BAR Meeting
January 5, 2011

ISSUE: Permit to Demolish/Encapsulate & Certificate of Appropriateness
(Alterations and Enclosure of an Existing Open Porch)

LOCATION: 325 South Lee Street

**BAR CASE #2010-0366
#2010-0367**

Figure 5: Existing Elevations

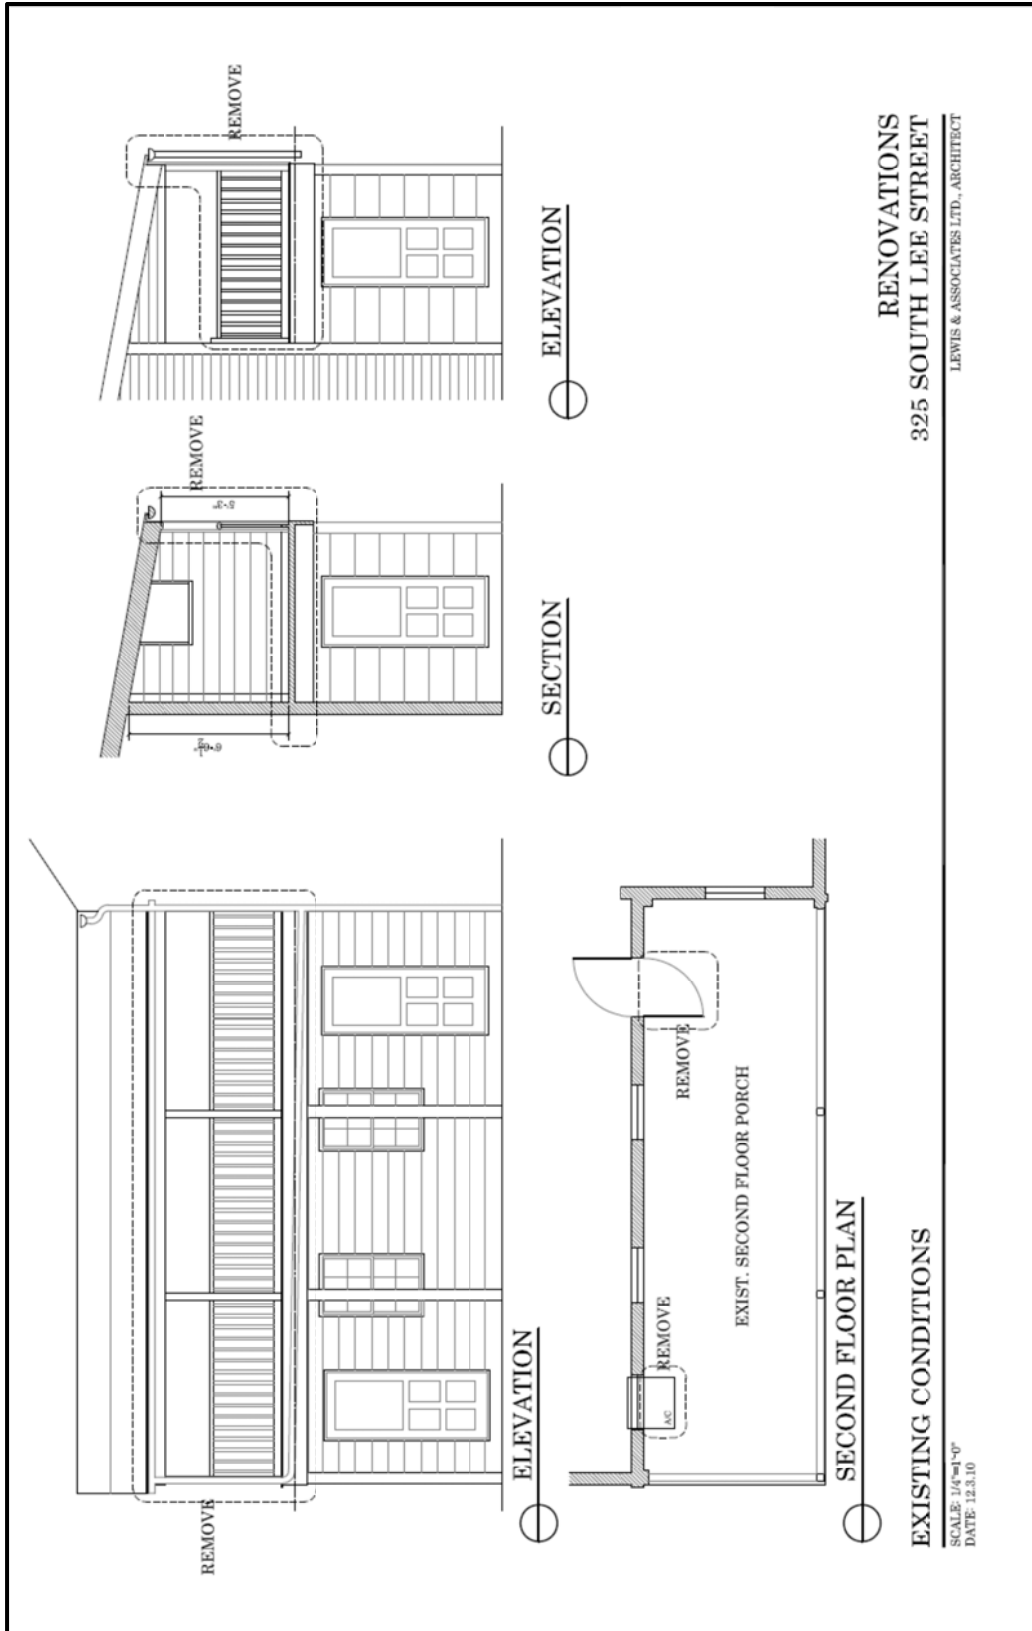
Staff's main concern is the encapsulation of the second floor wall. Because the siding, windows and porch ceiling have been protected from the weather by the porch roof, they appear to be first period materials and in remarkably good condition. The drawings illustrate that the homeowner intends to retain the exterior walls and the historic windows. However, once the second floor wall becomes an interior wall, the Board has no further purview when/if the current or a future homeowner desires to make changes or alterations. For this reason, Staff recommends that a conservation easement be donated to a local preservation organization for the second floor walls, windows and porch ceiling, ensuring that they remain intact after becoming interior features and to provide a future homeowner the option to reverse the porch enclosure. If the conservation easement is donated, Staff supports the demolition/encapsulation application as submitted. This

The *Design Guidelines* specify porches as “important architectural elements especially on residential structures. They can serve as a defining element of an architectural style.” The existing ceiling height of the second floor porch slopes to only 5’-3”. The building code will not allow this space to be enclosed with windows unless the ceiling is raised. To accomplish this, the applicant is proposing to lower the floor of the porch by approximately 1’-2”, to just above the lower level windows and doors. As the porch floor, the first floor columns, and first floor bead board ceiling have all been re-constructed in the 20th century, staff does not object to this proposed change. As shown in the illustration below, since the roof of the porch is being retained, the lowering of the porch floor will be a very minimal visual change. (The bold lines in the illustrations below indicate the bottom of the porch's skirt board.)

1. That the encapsulated walls, windows, doors and porch ceiling on the second floor be placed in a conservation easement, protecting these architectural features from future demolition.
2. That the reconstruction of the porch floor will not damage or cover any of the window or door trim or openings on the first floor and that the siding at this intervention will be carefully removed and reused, where possible.

Figure 6: Proposed Elevations

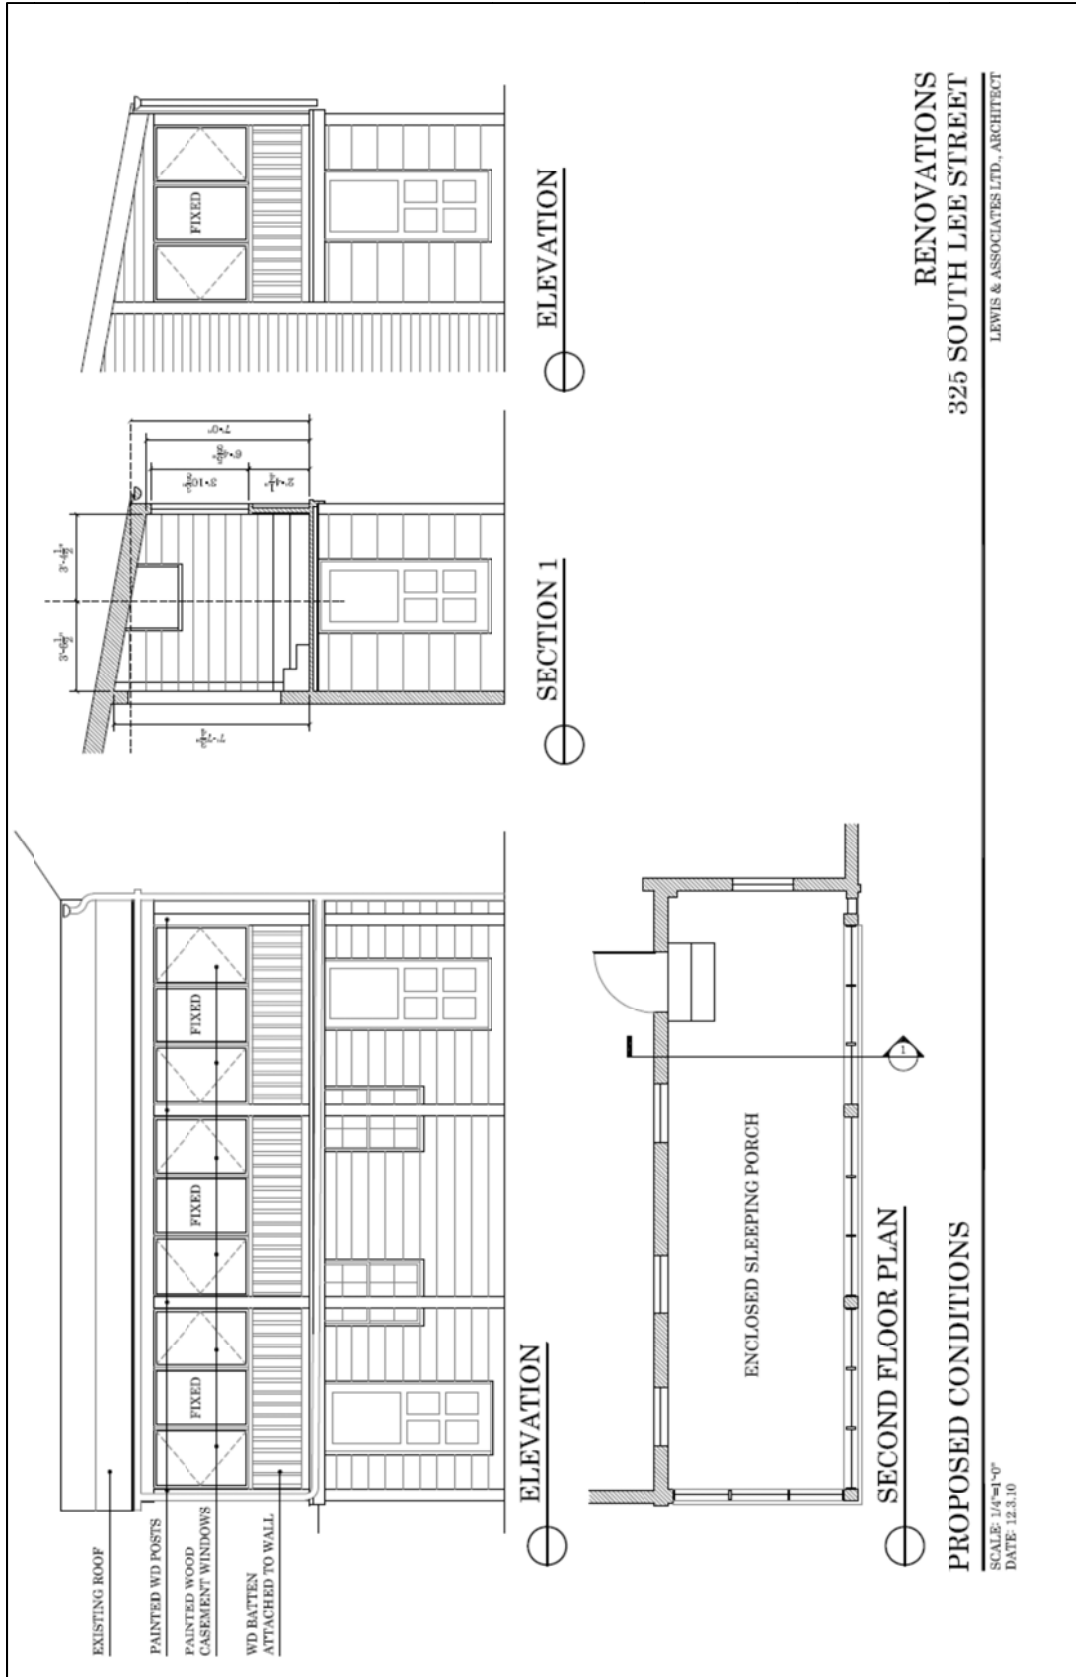
The proposed fixed glass and casement windows being utilized to enclose the porch will be mounted between square columns and above a knee wall detailed with battens to simulate a balustrade. This architectural detailing pays homage to the original open porch (see below), and is simple in detail and design. As it will be painted to complement the color of the predominant color of the building (white), it will blend in to the existing architectural details on the building and not negatively impact the resource as a whole.

Regarding materials, the proposed simple, single light, fixed and casement wood windows, painted wood posts and trim complements the main massing without being replicative. It is the opinion of Staff that the proposed porch enclosure's utilization of the historic shed roof, simple architectural detailing and use of an easement to preserve all of the identified historic material enables it to be a sympathetic solution for the current homeowners, yet a reversible change for a future generation.
